Maintenance Sheet
Plan Change Number:

Plan Name: Approved Rawlins Resource Management Plan

Section/Heading: Sand Hills/JO Ranch Area of Critical Environmental Concerns

**Sand Hills/JO Ranch ACEC
Proposed Updated Boundary
06.11.2013**

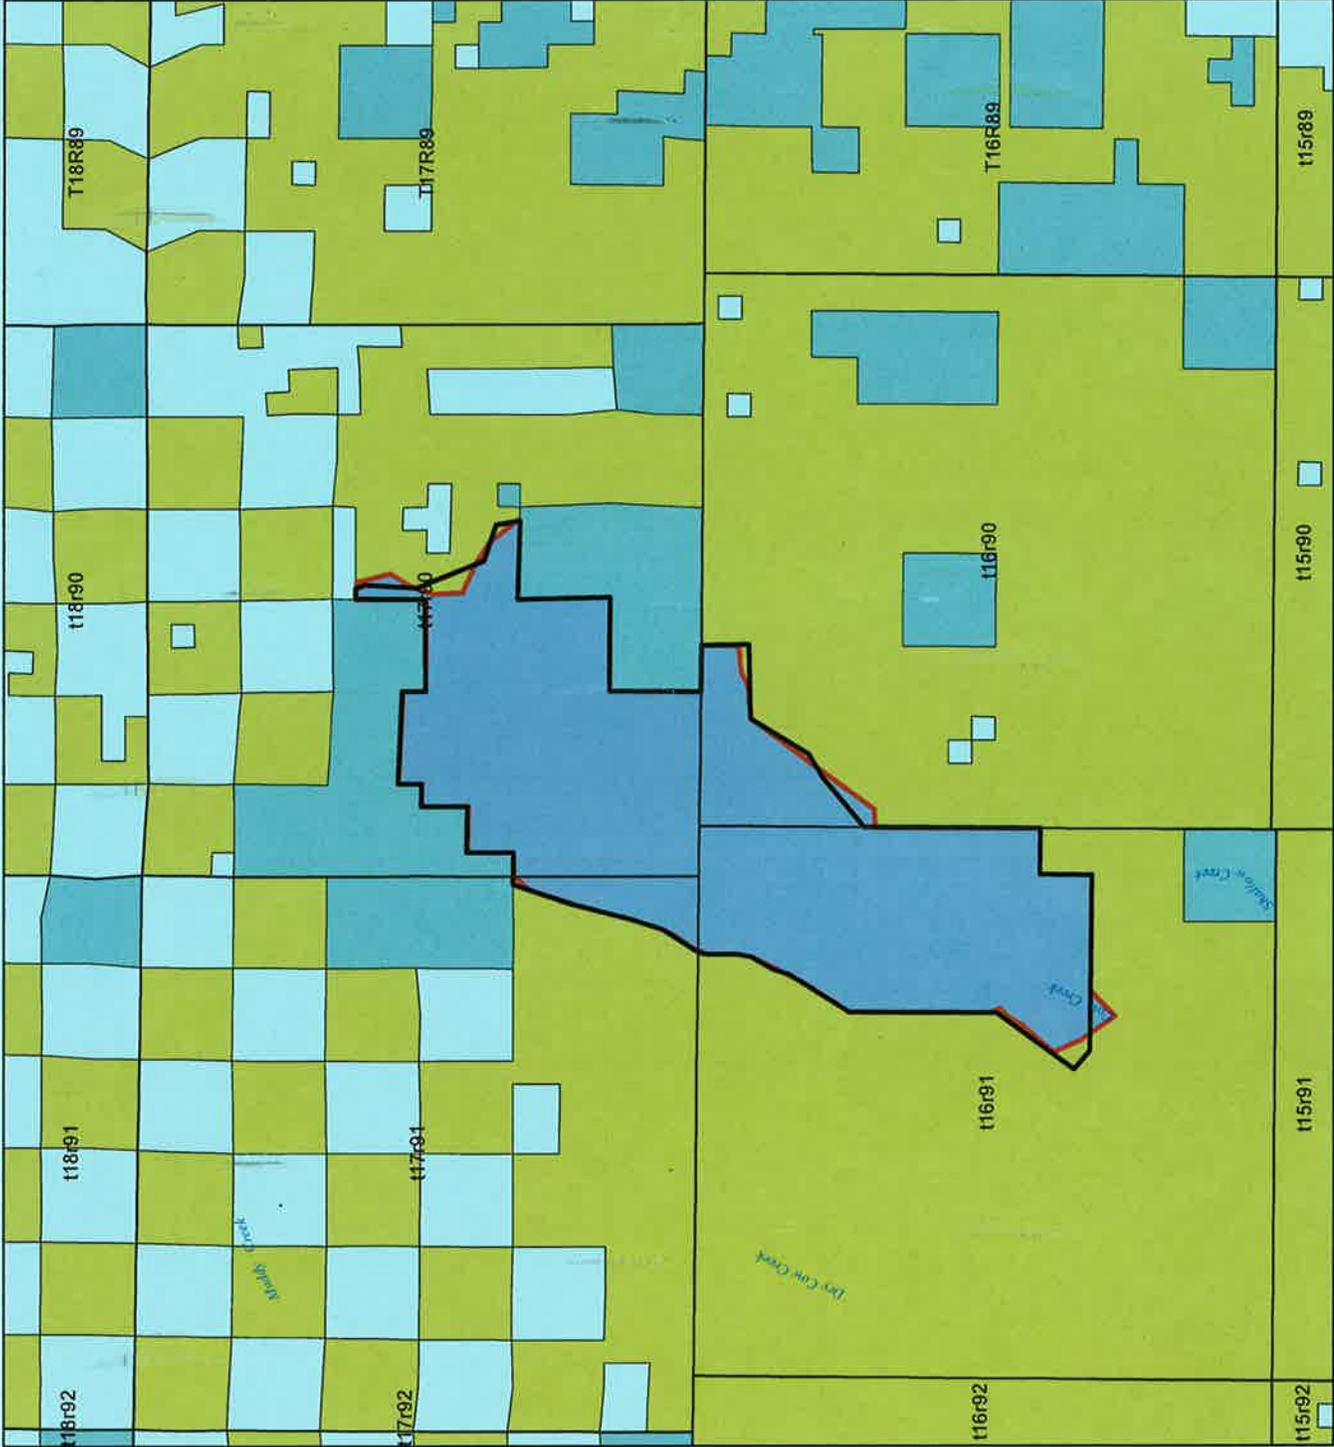
Please see attached map for change in the boundary of the Sand Hills/JO Ranch Area of Critical Environmental Concern. The boundary has been modified from the boundary illustrated in the 2008 Approved Rawlins Resource Management Plan (RMP) on Map 2-9c resulting in an increase of 64.4 acres. The original acreage was 11,937.6 acres. This maintenance action increases the acreage to 12,002.0 acres.

The original boundaries in the 2008 Approved Rawlins RMP were arbitrarily depicted, and did not accurately reflect the boundary. The new boundary follows existing fence lines and legal description for easy identification of the boundaries. Allows ease of boundary identification by users and visitors.
